Telopea

SSDA Response to Submissions II

Frasers Property Australia

25 November 2022

Proposed Envelope Plan - Locations of Nil Tower Setbacks

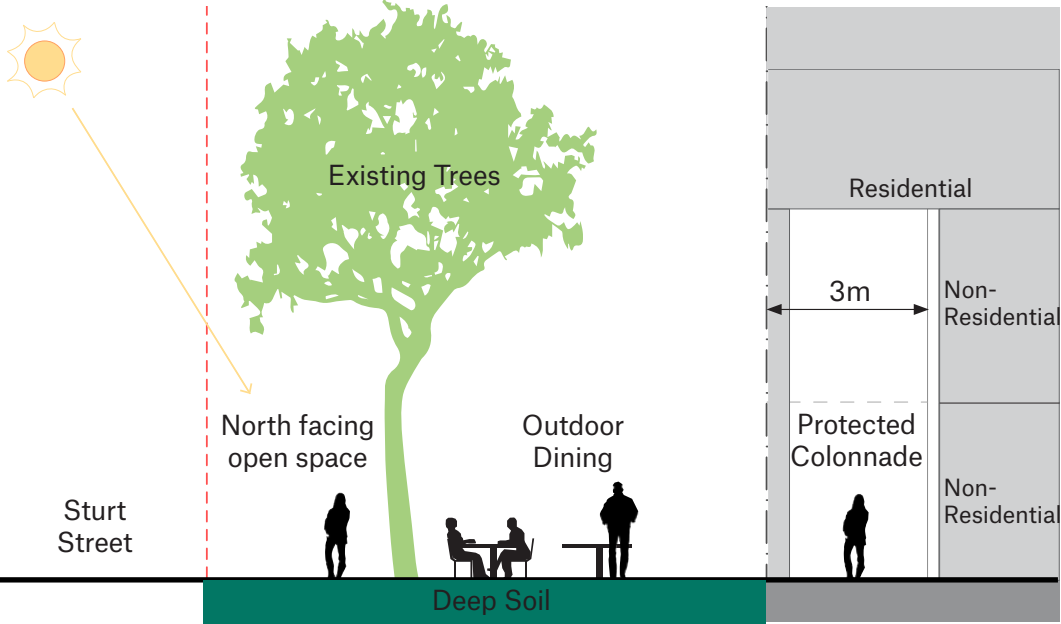
In the upper core area bounded by Sturt Street, Shortland Street and Manson Street, buildings should adopt a podium and tower typology with a street wall of 2-4 storeys and a tower which is generally set back a minimum of 3m (Figure 2).

- C1.1 Nil tower setback to Retail Plaza & Trees
- C1.2 Nil tower setback to Retail Plaza & Trees
- C2.1 Nil tower setback to Sturt Street Open Space

The design strategy provides great amenity to the public domain in a slightly different configuration, creating new north facing open spaces around existing trees

Lot E1 - Alternative Envelope

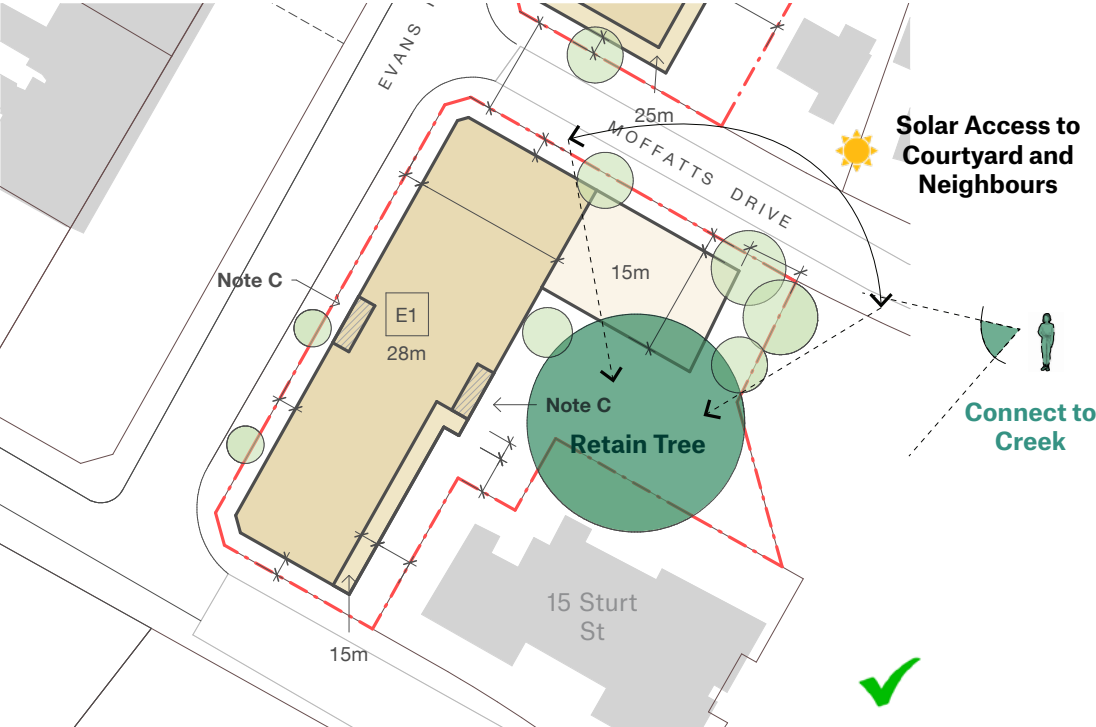
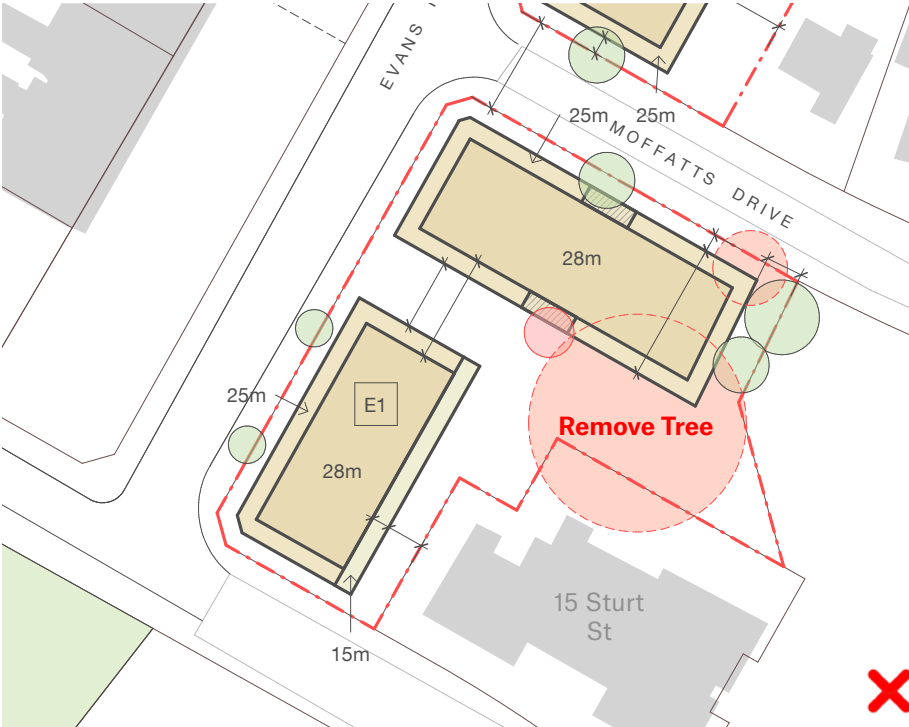
- Consider breaking up Building E1 (Measuring 76m) into two separate building envelopes

An alternative envelope, splitting the core into two buildings sees two 8-storey, 22.5m deep building envelopes that front Evans Road and Moffatts Drive separately. The development yield is like-for-like however comes at significant cost to the amenity of residents and neighbours.

- Tree Retention Category AA Tree - 1 Removed
Category A Trees -2 Removed
OVERALL THREE TREES LOST
- Landscape Rear courtyard is enclosed and
has poor solar access
- Public Domain No visible connection of landscape to Creek,
Spotted Gum has been removed
- Amenity Poorer views, solar access and building
separation to 15 Sturt Street
- Diversity Poorer diversity
- Two 8 storey buildings
